District Department of Transportation

# **Roadway Safety Audit Edgewood Road Washington, DC**

DDOT Traffic Engineering and Safety Team

September 2, 2014

**Figure 4 – Illegally Parked and Standing Vehicles on Bus Pad**

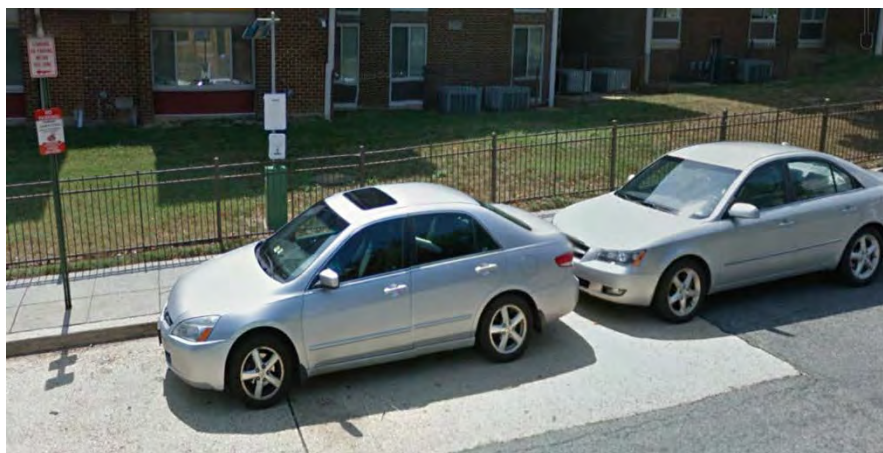
- There are parking restriction signs on Edgewood Street that prohibit parking in a bus zone. However, as shown in **Figure 4**, motorists were observed to parking and standing illegally in the bus zone. Further, the RSA team also observed parents illegally standing and parking their vehicles in the bus pad for drop-off purposes during the morning peak-hour. This creates direct conflicts between Metro bus operations and vehicles that are illegally parked and standing on the bus pad.

**Figure 7 – School Bus in Wrong Lane**

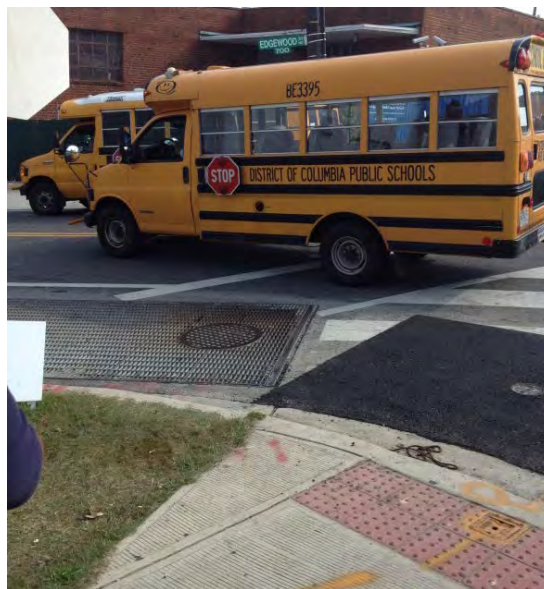
- The RSA team also observed a few motorists, especially school buses, traveling in the wrong travel lanes. This deliberate motorist behavior of driving in the wrong travel lanes, significantly increases the potential for head-on collisions, injury-related crashes and fatal crashes. **Figure 7** shows school buses traveling in the wrong travel lanes at this location.

**Figure 9 – Obstruction at Pedestrian Ramp**

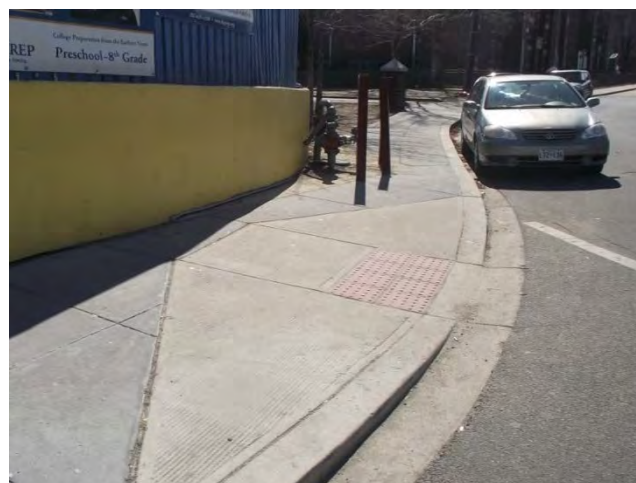
- The traffic control signs are either damaged or incorrectly mounted at this location (as shown in **Figure 8**). Further, there are no advance warning signs for the school zone installed at this location. The pavement markings for the existing crosswalk are faded and need to be replaced.
- The utility pole is installed very close to the pedestrian ramp, as shown in **Figure 9**. The utility poles obstruct access, especially for wheelchair users, to pedestrian facilities. It should also be noted that the sidewalk is very narrow at the terminus of the pedestrian ramp, and there is not enough turning space for wheelchair users to maneuver after leaving the crosswalk.

**Figure 15 – Damaged Pedestrian Ramp**

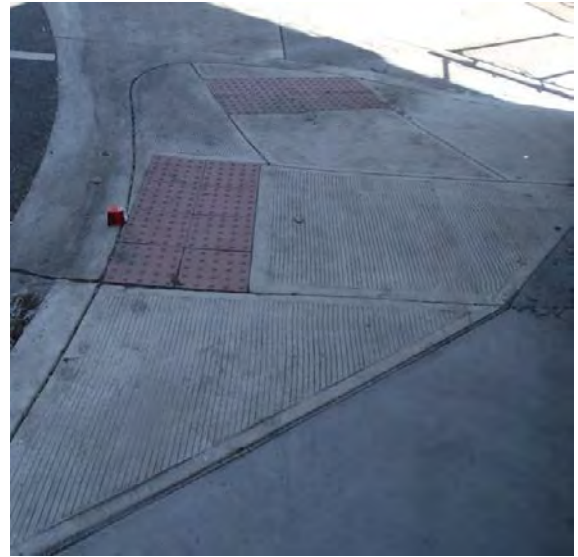
- Edgewood Street transitions to 8<sup>th</sup> Street, NE underneath the Franklin Street Overpass. There are two pedestrian crosswalks at this location. The pedestrian ramps at both crosswalks are non-standard and do not meet any ADA specifications.
- The landing areas at ramps are either missing or damaged. Further, the cross slopes are steep which create safety hazards for pedestrians, particularly wheelchair users. **Figure 14** and **Figure 15** show the non-standard and damaged ramps, respectively at this location.

- The pavement markings at existing crosswalks are either faded or completely missing and should be replaced with new markings. Some of the traffic signs are also worn-out and should be replaced with new signs at this location.

**Figure 17 School Valet Layout**

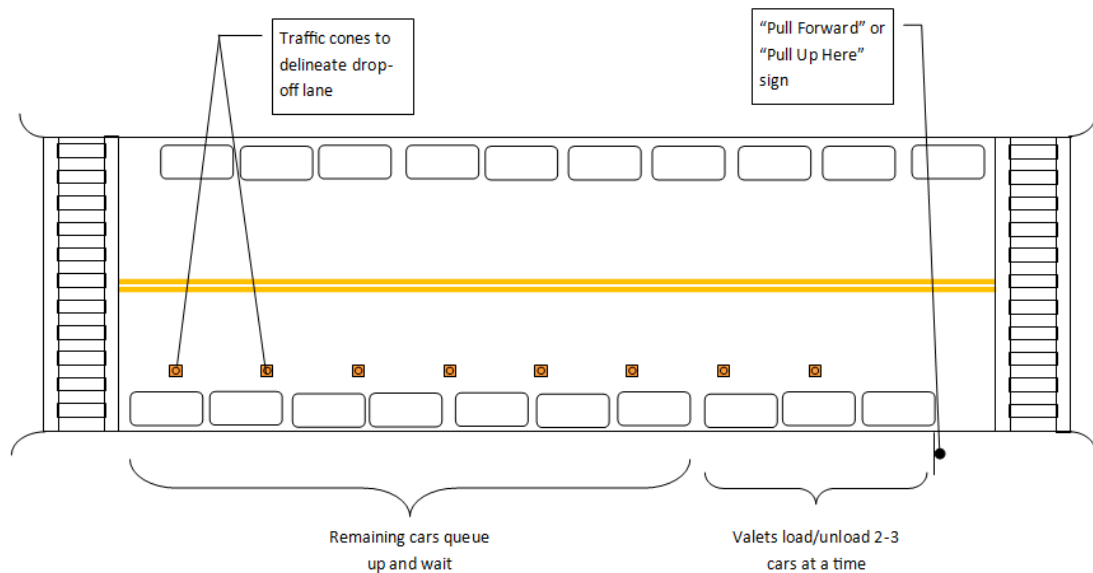
- Schools should coordinate with MPD for enforcement and issuing warnings or tickets
- The school valet area should be delineated by using appropriate traffic signs and traffic control devices. Some schools put out cones to delineate the drop-off only lane as shown in the **Figure 17**. The cones are placed between the drop-off lane and the travel lane. The idea is that parents pull in at one end of the drop-off lane, and leave from the front. Parents are not allowed to enter or leave the drop-off lane anywhere in the middle and are instructed to stay close to the car in front of them. Putting a “Pull Forward” or “Pull Up Here” sign at the very front of the drop-off/pick-up area is also helpful to show parents where to stop. Position the valets near this location.
